# Access Compliance Report

## Public Rights-of-Way

Intersection ID: 31878	Main Street: LANGDEN_GATE_DR	Cross Street: WILLIAMS_GLENN_RD	Location: NW
ADA ID: A732DB07122F	Ramp Type: PerpDiag	Initial Pass/Fail: Fail	Overall Compliance: No
Severity Score: 22.5			
Codes/Mitigation Info/Possible Solution		Field Measurements/Component Compliance

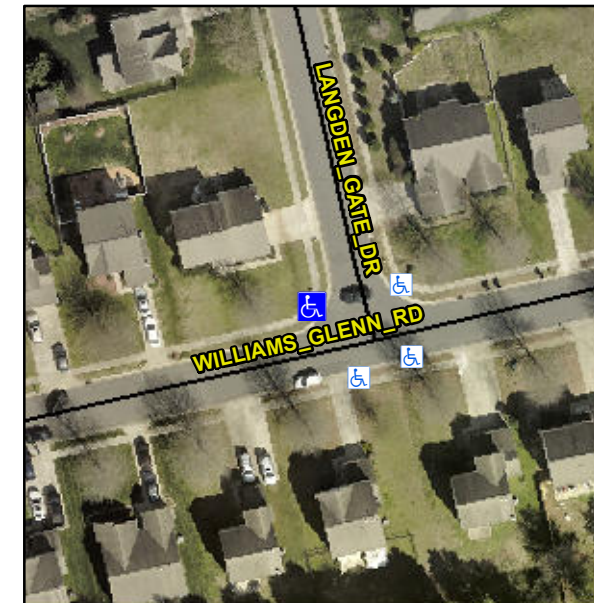
**Remove & Replace Curb Ramp With Two New Directional Ramps or Equivalent.**

**R304.5.1, R304.2.2, R304.5.3**
